**Re: Responses to Technical Review Comments  
Dewey-Burdock Project Large Scale Mine Permit Application**

On behalf of Powertech (USA) Inc., this letter is provided in response to the technical review comments issued December 14, 2012 and March 1, 2013 for the above-referenced large scale mine (LSM) permit application. For convenience, the comments are provided below in italics followed by the responses. Application replacement pages are enclosed along with an index of changes (three hard copies and one electronic copy on CD). The replacement pages are included as individual PDF files that correspond to the changes shown on the index of changes. For convenience, the enclosed CD also includes a folder with replacement pages incorporated into the application text and appendix files. Only files that were updated as a result of the comment responses are included. In addition, Attachment A provides pre-operational and end-of-production water quality from operating ISR facilities as requested in comment #5.

**Figure 1. Baseline Soil Salinity Profiles - Burdock Land Application Area**

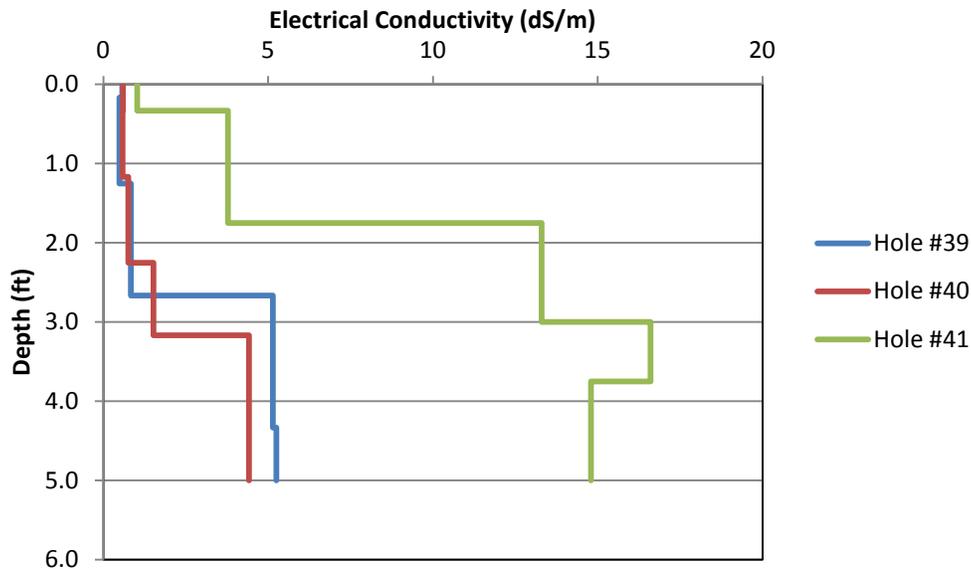
*Please discuss the potential for the buildup of salts in the soil profile and the development of saline seep conditions in the land application area. Also, please describe the measures Powertech plans to take to mitigate any problems that develop from salt buildup and saline seep.*

**Response:** Potential salinity impacts in the land application areas are a function of the baseline soil salinity, land applied water quality, leaching practices, and reclamation crop salinity tolerance. Each of these is described below.

Baseline soil salinity profiles for soil samples collected from within or near the Burdock and Dewey land application areas are presented in Figures 1 and 2. These were generated using the laboratory-measured saturation extract electrical conductivity (EC) presented in Appendix 3.3-A. The salinity profiles represent typical soil salinity conditions in this semiarid area, with baseline soil salinity increasing with depth. These figures show that the top 1 to 3 feet, where most of the plant root zone is located, has salinity ranging from about 0.5 dS/m to greater than 5 dS/m. The salinity from 3 to 5 feet below ground surface is considerably higher, ranging from about 5 to 15 dS/m. According to the *Western Fertilizer Handbook* (California Plant Health Association, 2002), soils that have a conductivity of the saturation extract greater than 4 dS/m and exchangeable sodium percentage (ESP) less than 15 are considered saline soils. Figures 1 and 2 show that generally the near-surface soils do not meet this classification, although there are some instances where the baseline salinity in the top 3 feet exceeds 4 dS/m. Note that the highest levels of baseline soil salinity are associated with samples collected in or near drainage bottoms (#41 and #73) and may not be as representative as the other samples of typical land application baseline soil salinity (refer to Plate 3.6-1 for soil sample locations).
